**From:** [Adam Trimble](#)  
**To:** [Julie Adams](#)  
**Subject:** RE: Questions for the LMN consultants: Columbia Theatre Certificate of Appropriateness - ActionItem:00007:hopqL  
**Date:** Tuesday, May 06, 2008 8:31:34 AM

**From:** Adam Trimble [mailto:[adam.trimble@ci.longview.wa.us](mailto:adam.trimble@ci.longview.wa.us)]  
**Sent:** Friday, April 25, 2008 12:06 PM  
**To:** Julie Adams  
**Cc:** Steve Langdon; John Brickey  
**Subject:** FW: Questions for the LMN consultants: Columbia Theatre Certificate of Appropriateness

Columbia  
Theatre Chiller

A005

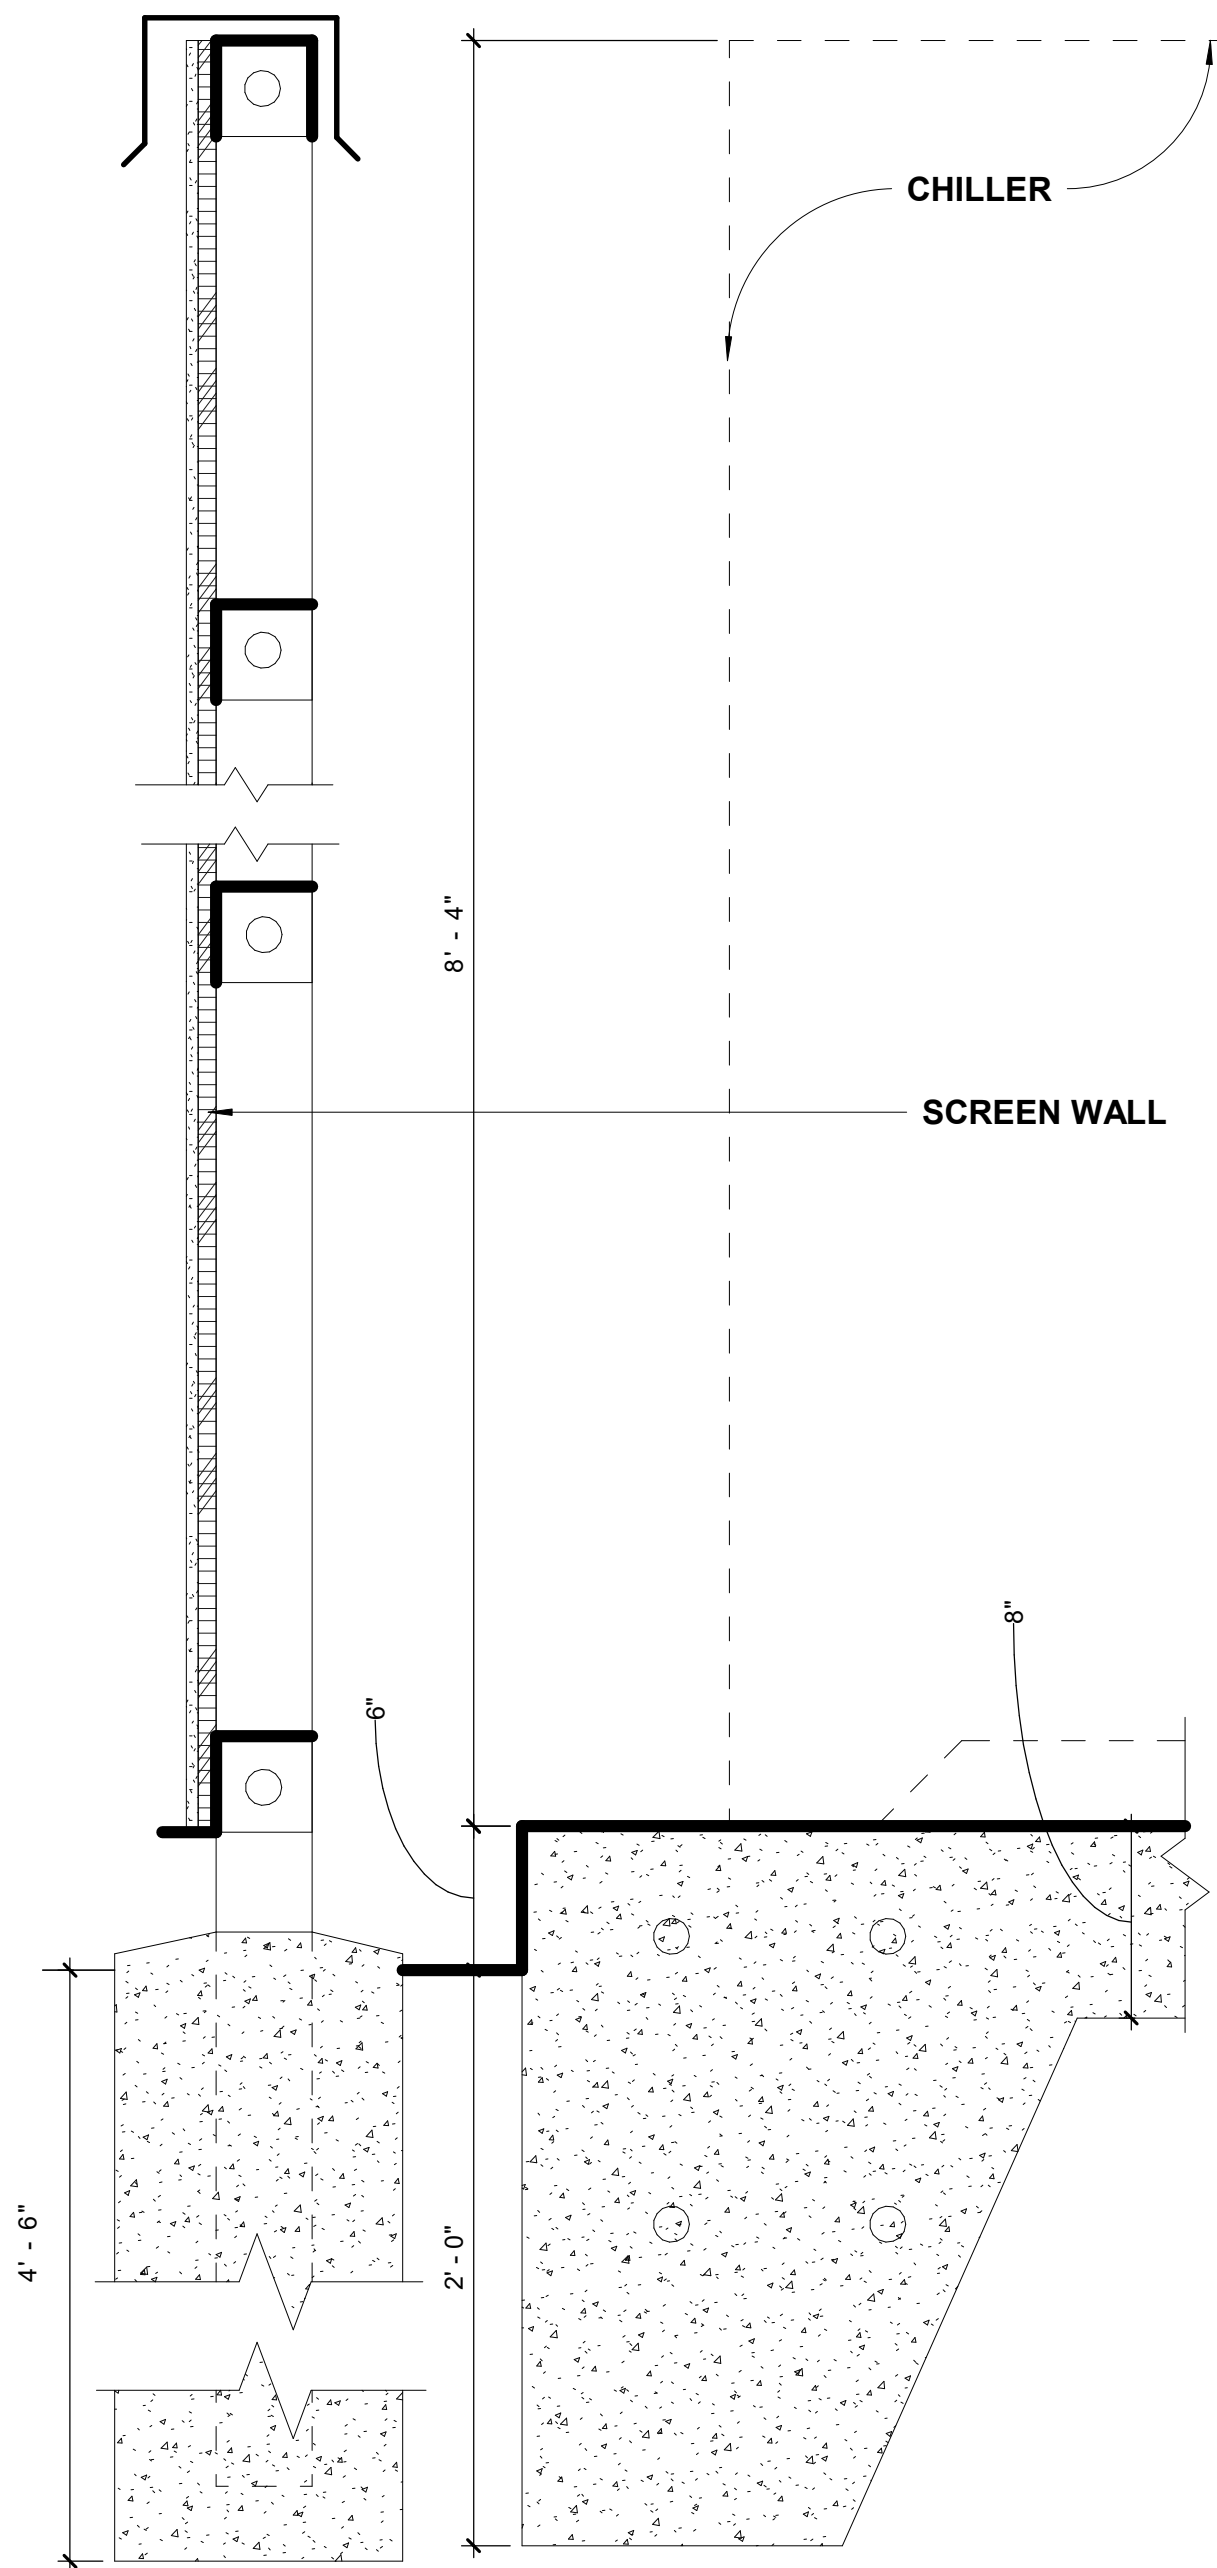
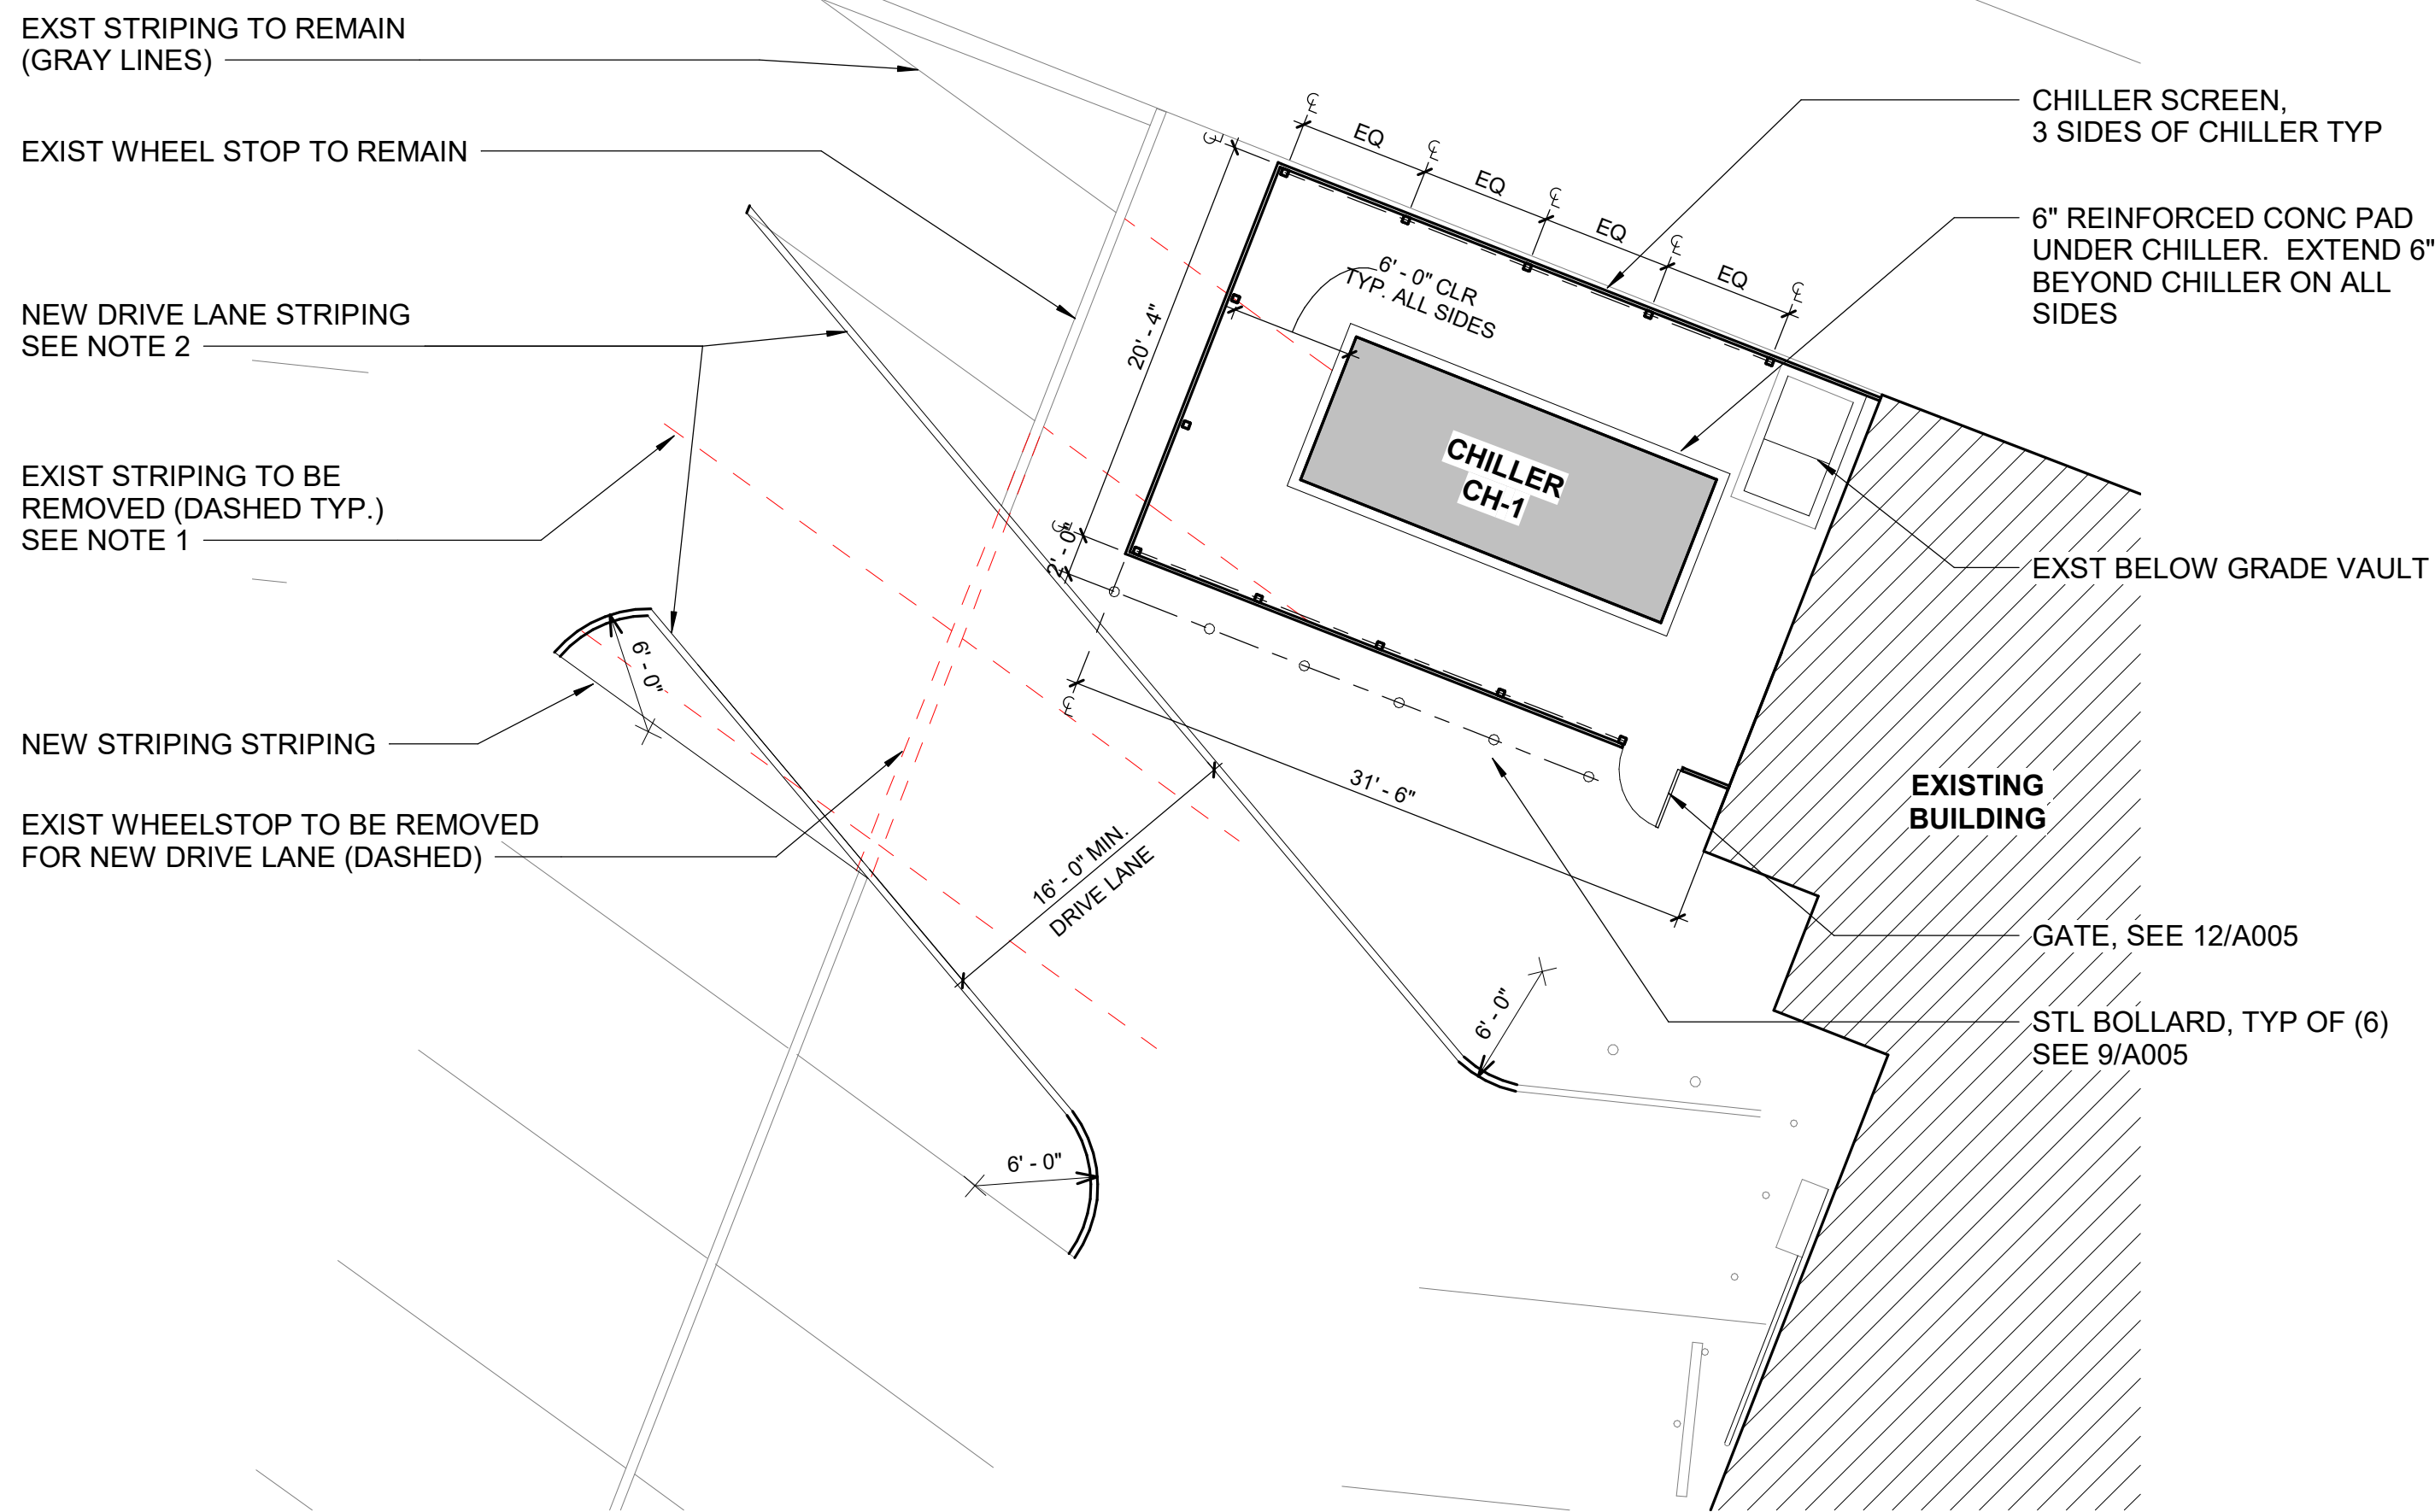
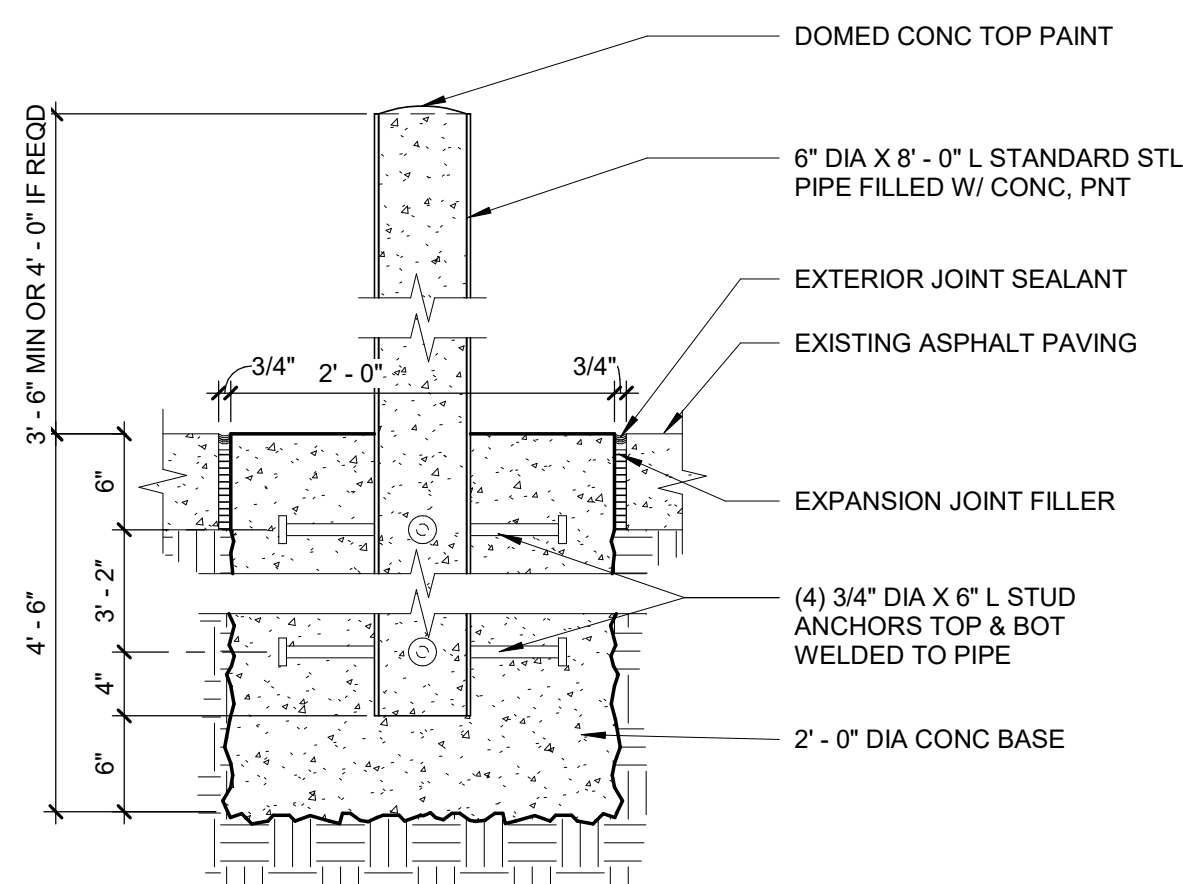
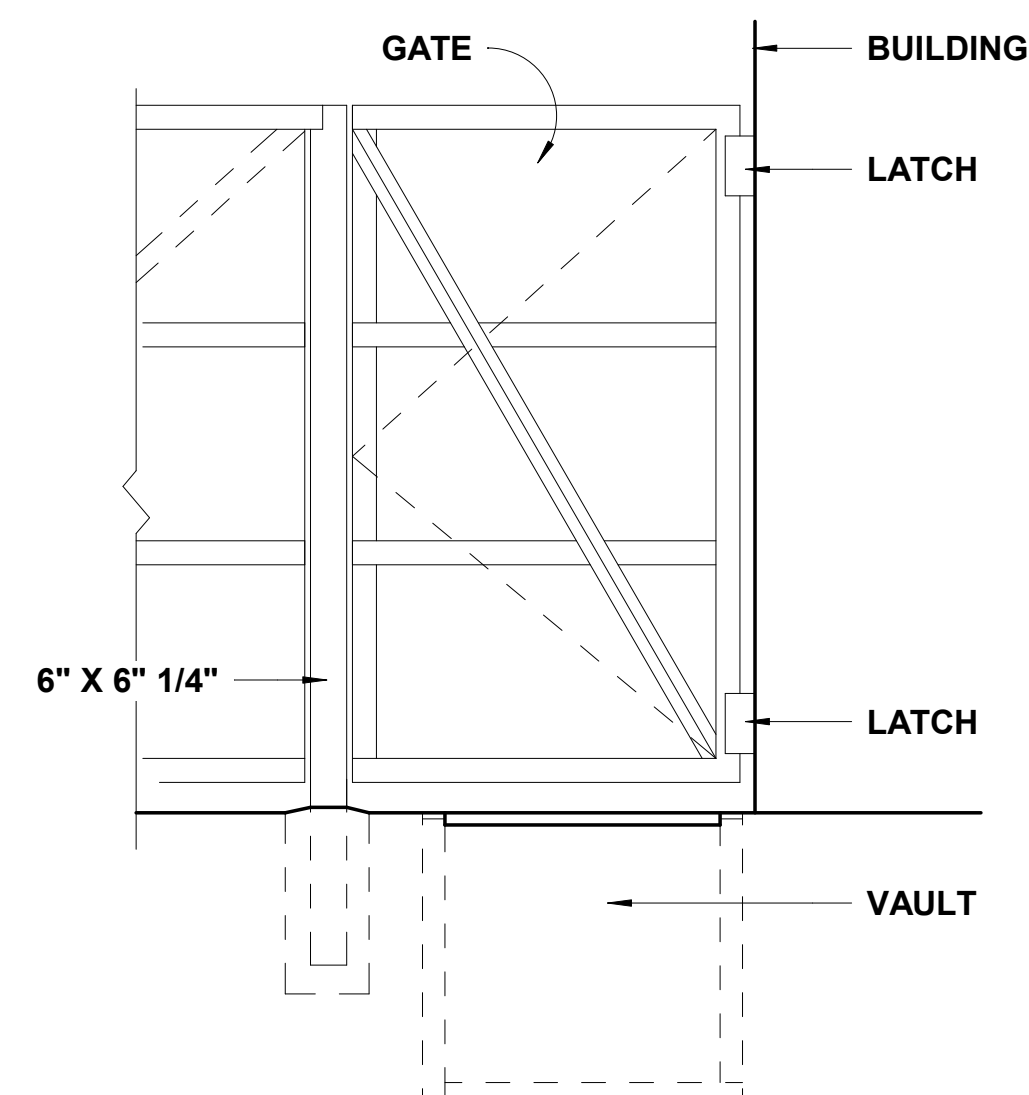
- 2) Mr. Hanna also asked about the proposed fencing around an optional proposed air conditioning unit to be located in the parking lot. Questions were raised about noise levels, the visual aspects of the screen or masking fence, and the impact on the parking stall count. More information on this AC unit proposal is desired.

- a. Commission desires total compatibility with the existing facades...

- b. Commission would like to see notation that the proposal is sensitive to, and accommodating of, the tenants and surrounding businesses.

**LMN Response:** *We are working to finalize details that will meet these suggestions.*
